Memorandum to the City of Markham Committee of Adjustment

File: A/32/19
Address: 14 Buttonfield Rd, Markham
Applicant: Yue Sun & Zhang Ying
Agent: Henry He
Hearing Date: Wednesday January 22, 2019

**Re: Minor Variance Application – A/32/19
14 Buttonfield Road, Markham
Owner(s): Zhang Ying & Yue Sun
Agent: Henry He**

DRAWING SHEET: SITE PLAN

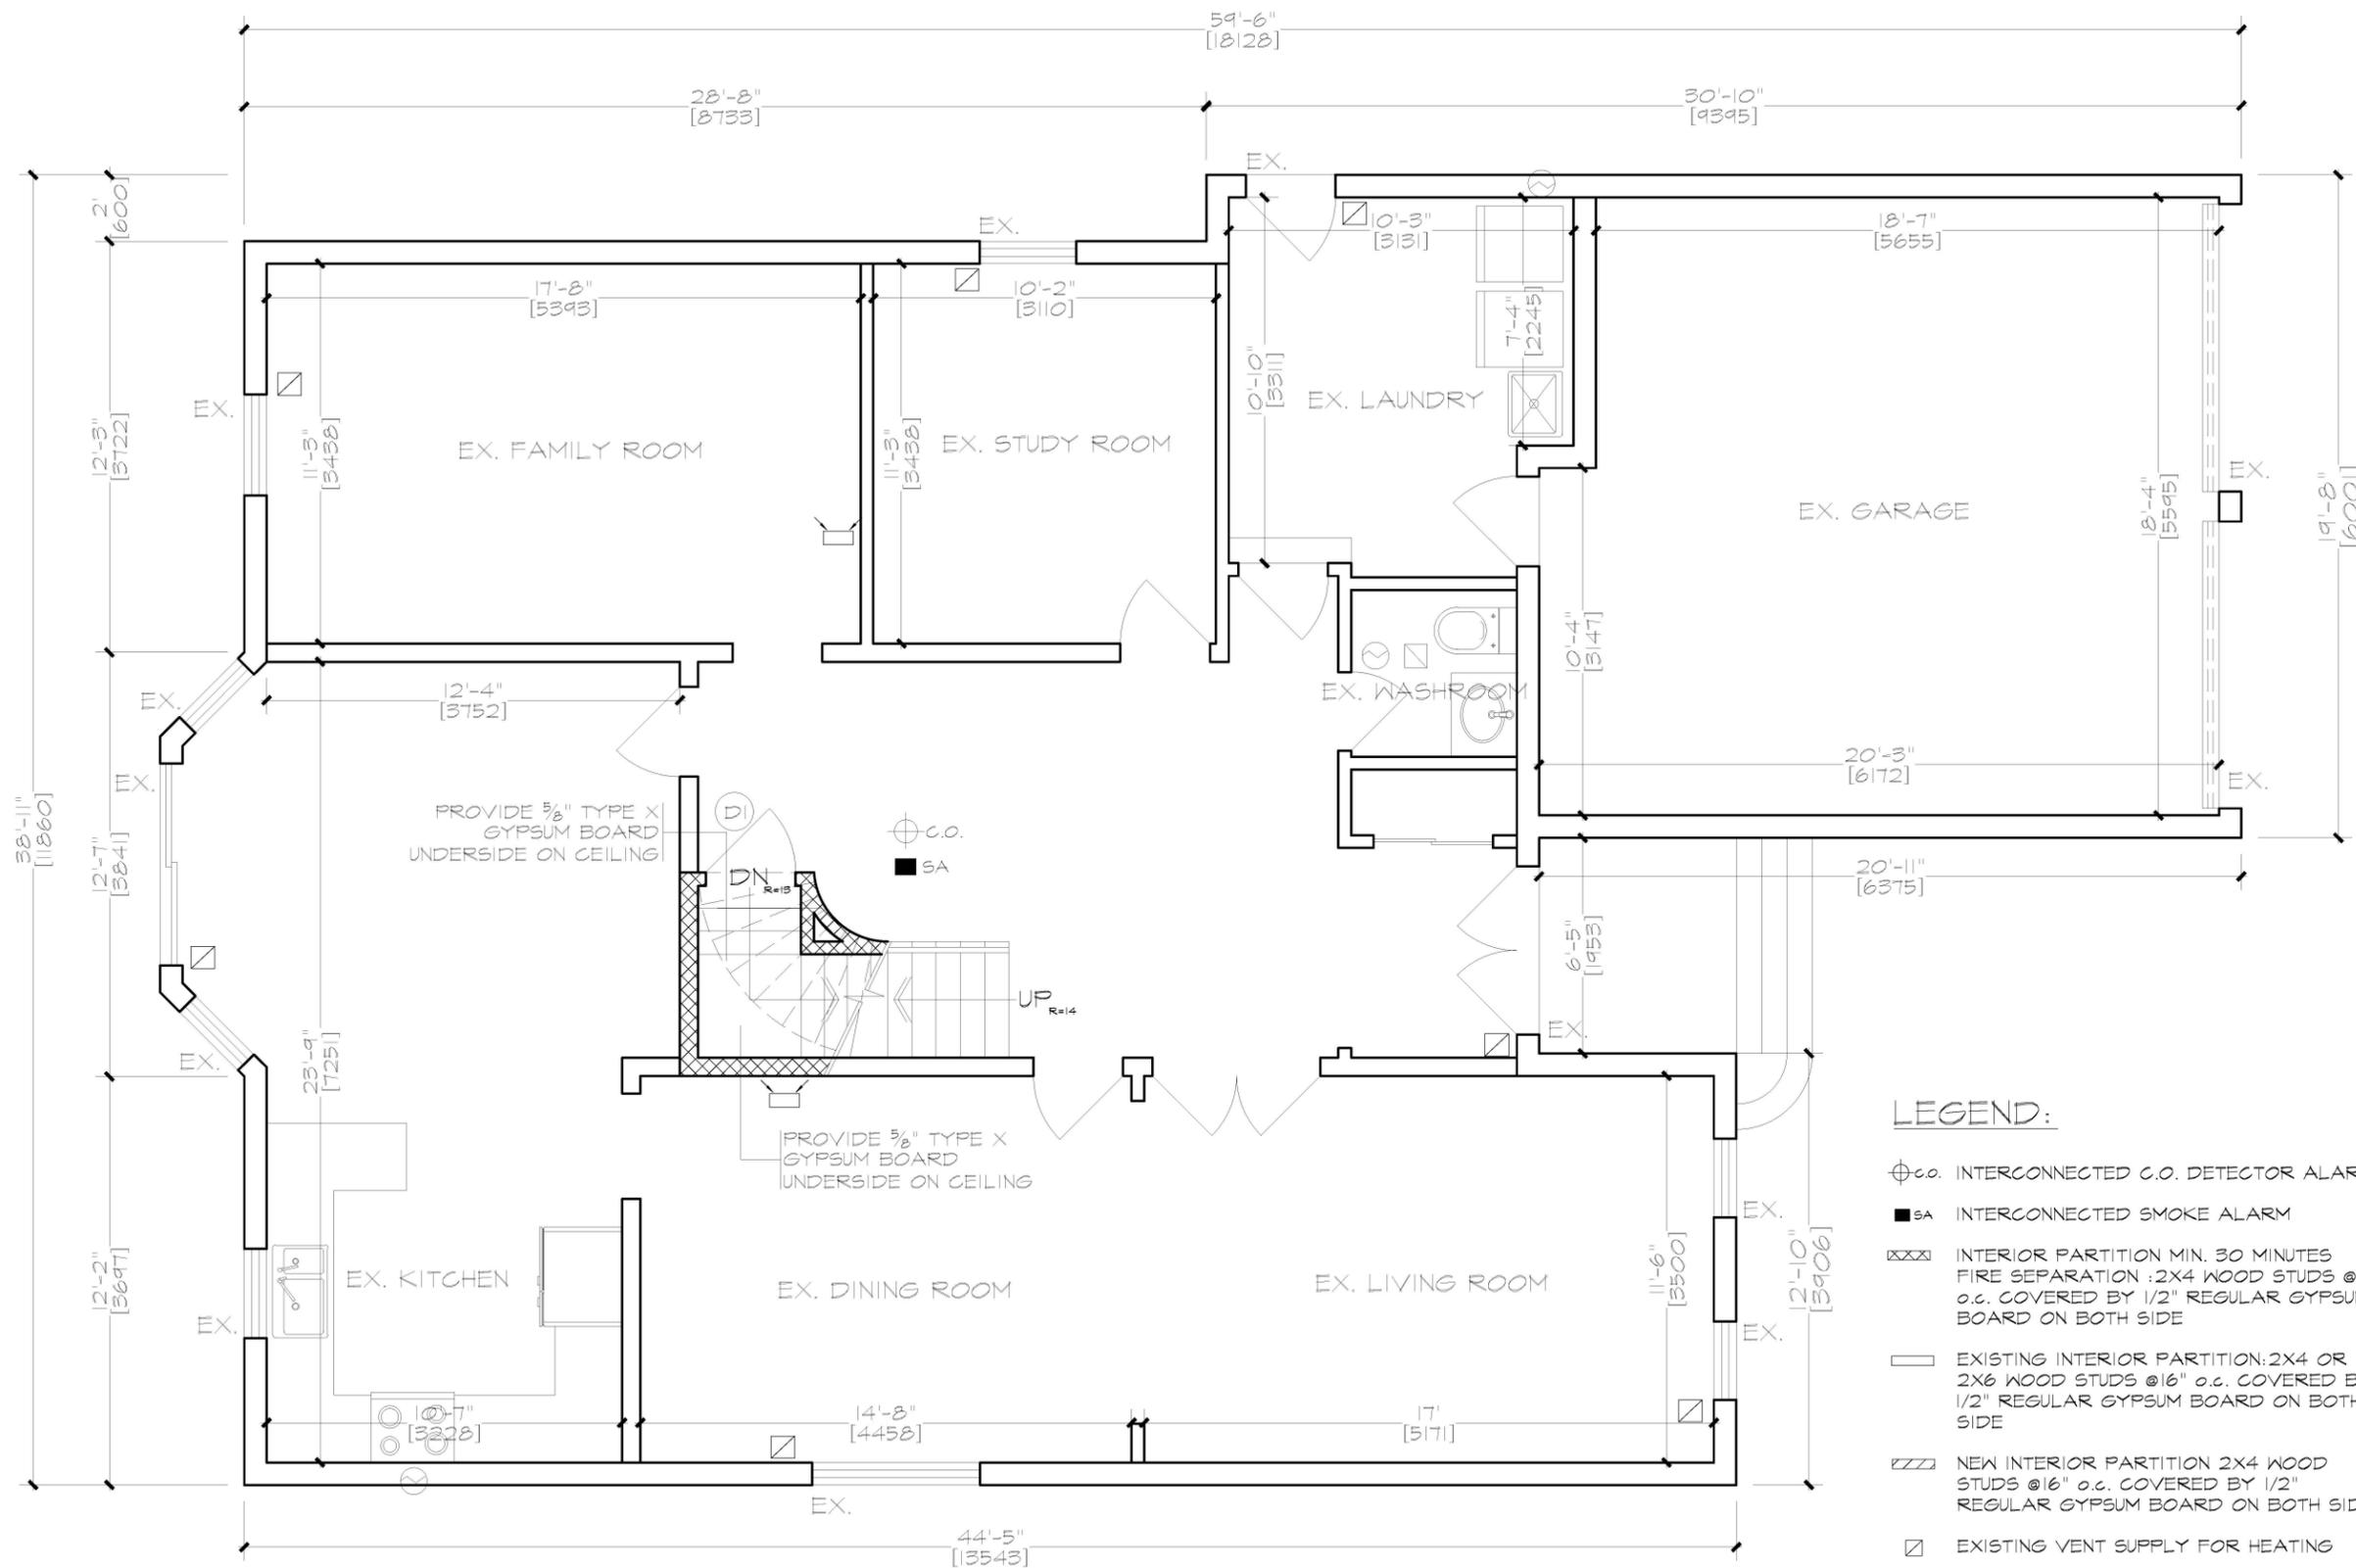
It is our understanding that the applicant is requesting relief from the requirements of By-law 118-79, as amended, to legalize an existing secondary suite. Due to the sensitivities of adding an additional dwelling unit within the flood hazard, TRCA staff must be satisfied that the existing building is located outside of any hazardous lands. As such, TRCA staff request that a topographical survey with the water surface elevation (191.18 masl) of the Regional Storm is plotted accurately on the drawing.

Please note, TRCA does not support secondary suites within buildings that would be inundated with flood waters during a Regional Storm Event. Furthermore, a permit application will be required, if the development application can be supported by the TRCA. At this time, please wait until the flood hazard is delineated on a topographic survey.

- 1) The applicant submits a topographic survey with the flood hazard accurately delineated to TRCA’s satisfaction;
- 2) TRCA requests that the applicant remits the outstanding review fee of \$580.00 within 60 days of the issuance of this letter.
